SUBJECT: Requests NRC review & approval of change to PVNGS grid  
stability analyses due to construction of new high voltage  
transmission line over two of five transmission lines which  
serve station.

**Subject: Palo Verde Nuclear Generating Station (PVNGS)  
Units 1, 2, and 3  
Docket Nos. STN 50-528/529/530  
Request for NRC Review of Revised Grid Stability Analyses**

**REVISED GRID STABILITY ANALYSIS (UFSAR  
SECTION 8B) AND REVISED UFSAR PAGES**

GRID SYSTEM  
 (SHEET 1 OF 2)  
 Figure 8.1-1

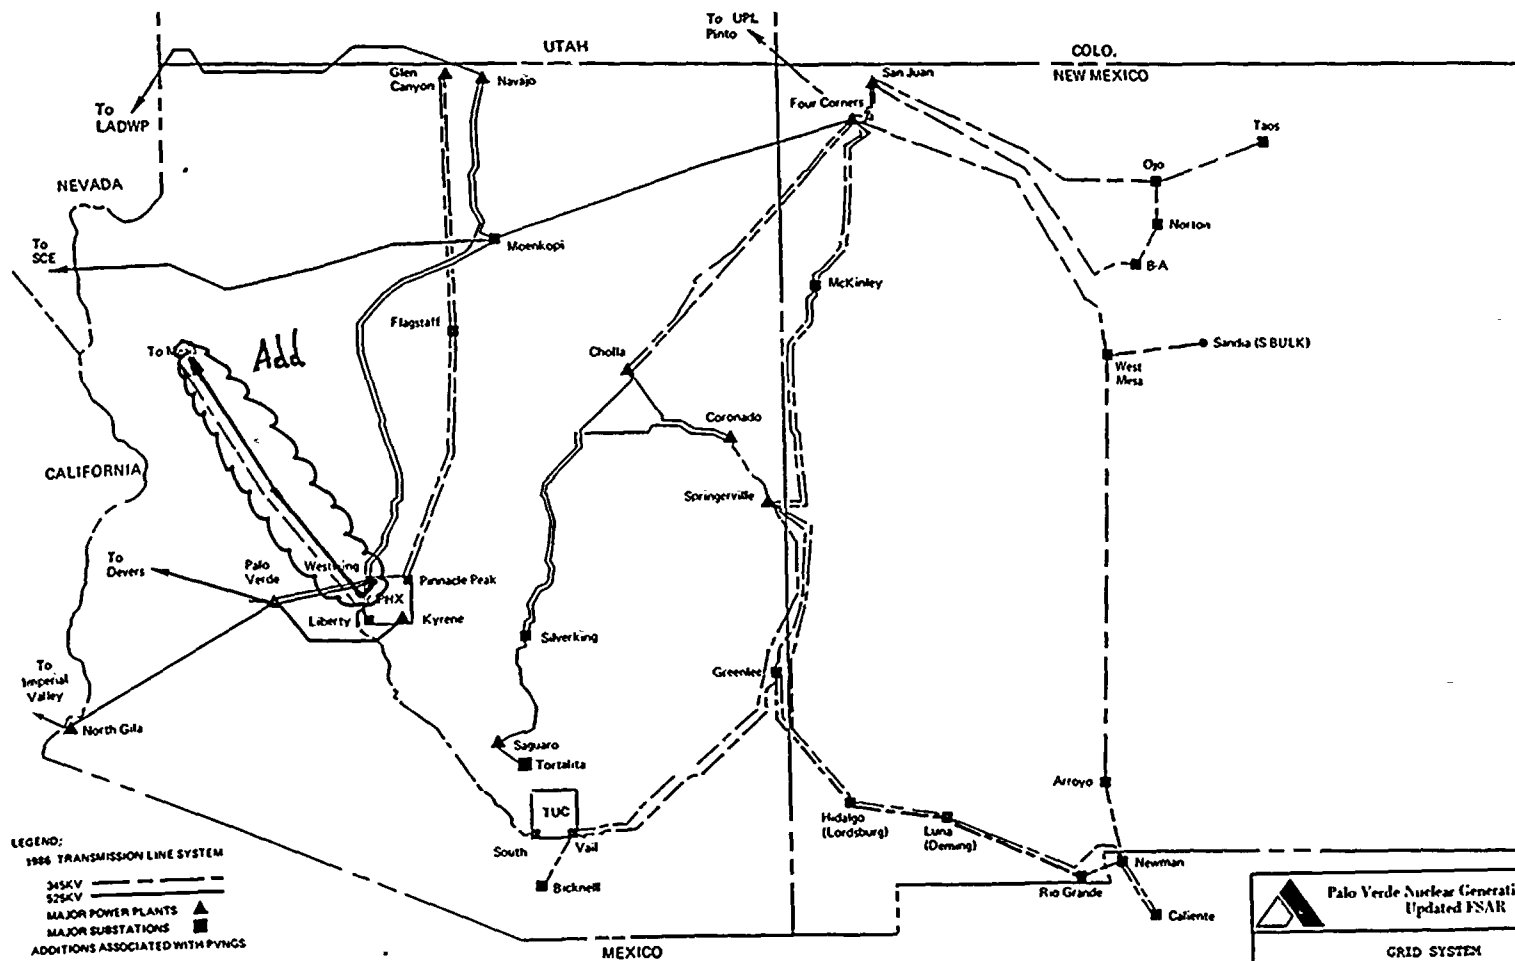
E. Affected Updated Final Safety Analysis Report Pages

Figure 8.1-1

Figure 88.1-1

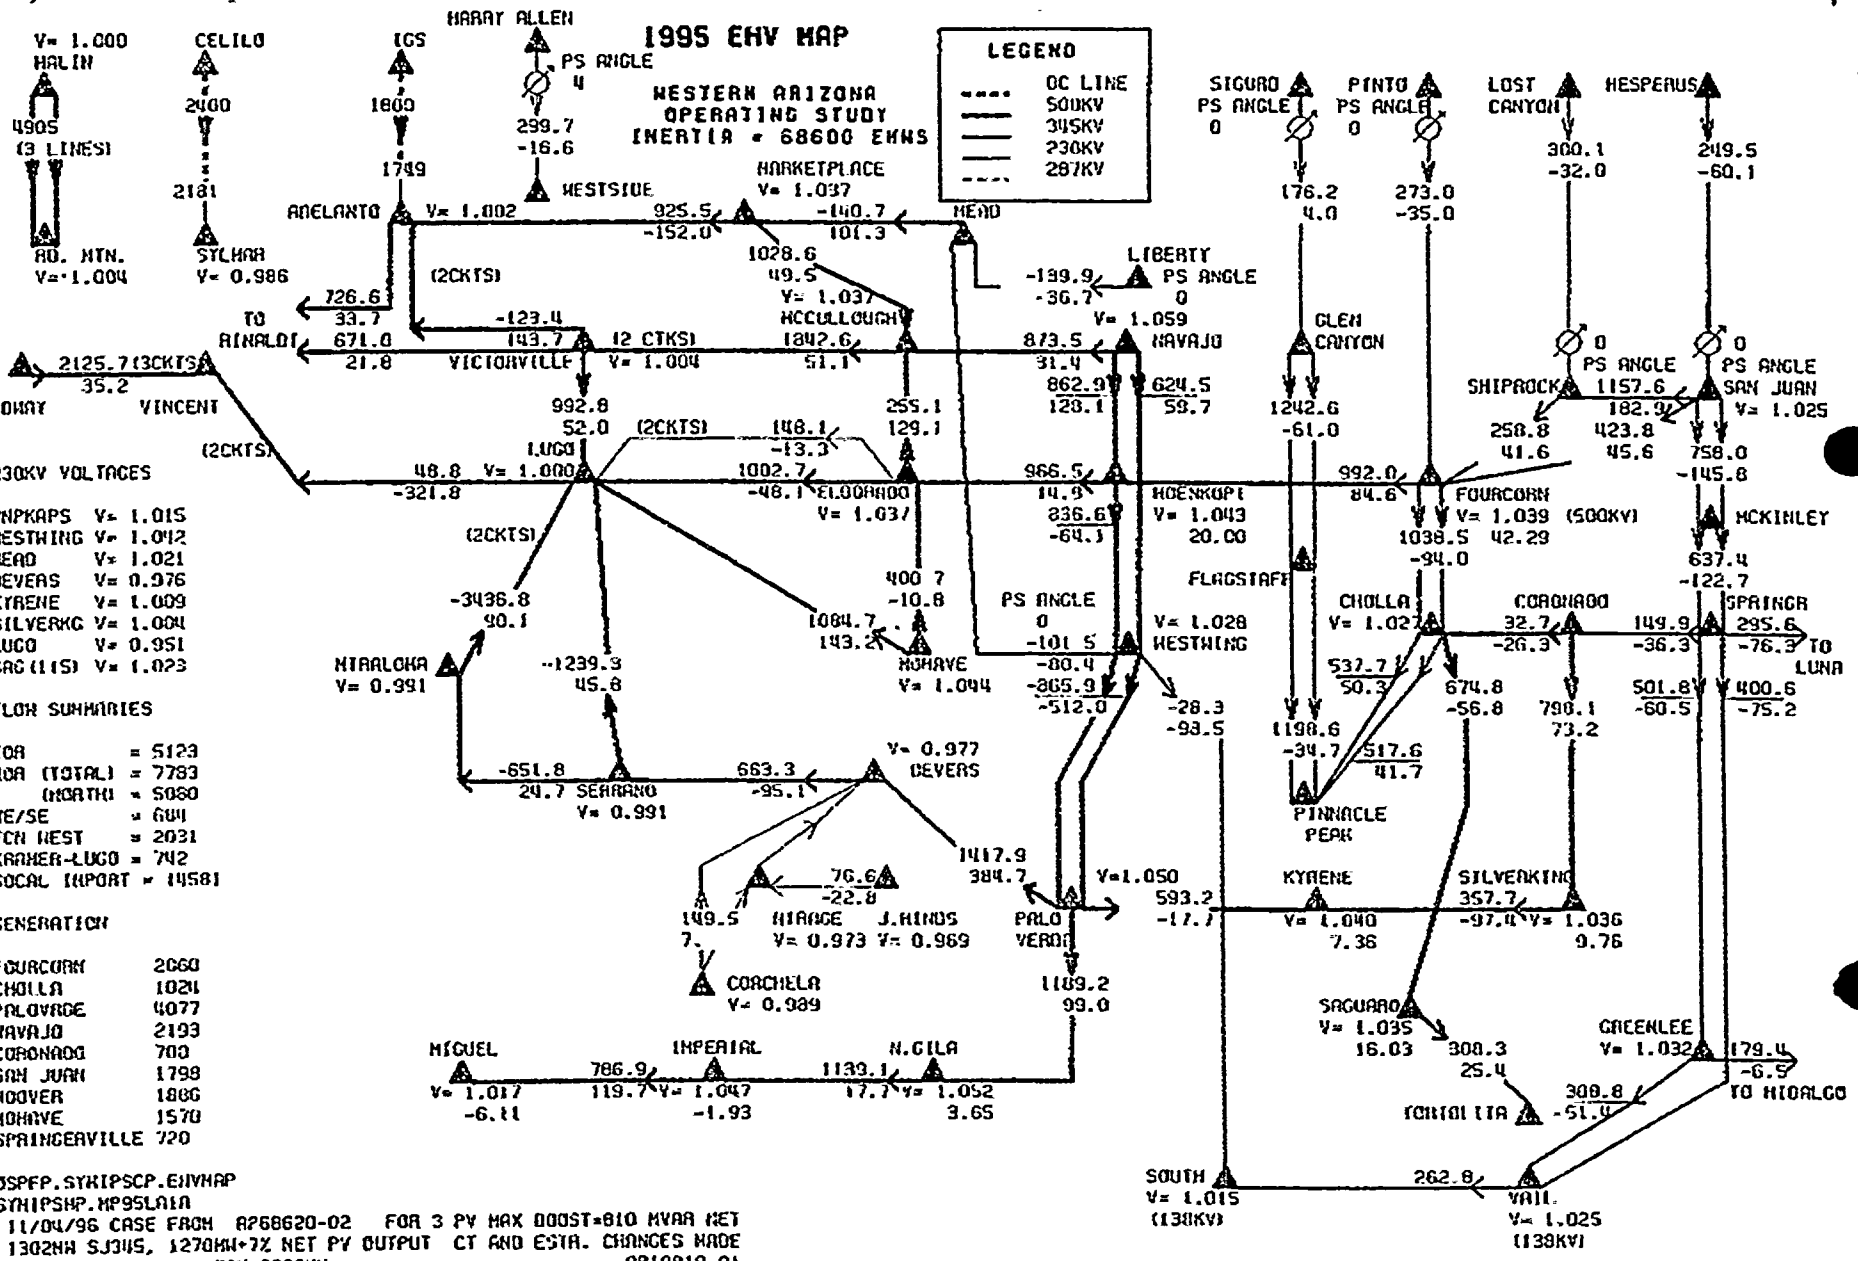
APS STAB STUDY FOR 3 PV Boost CASE; line drop in; 4077 PV NET EOR=5121MW  
(fl02hspv) (plotfsar) 10810r1.asif(distpww55) 11/05/96 WWPV OUTAGES  
TI 3PHS WW FLT LOSS OF WW-PV LINE #1&#2; 4C CLR; WPHX CC ADD; stab536
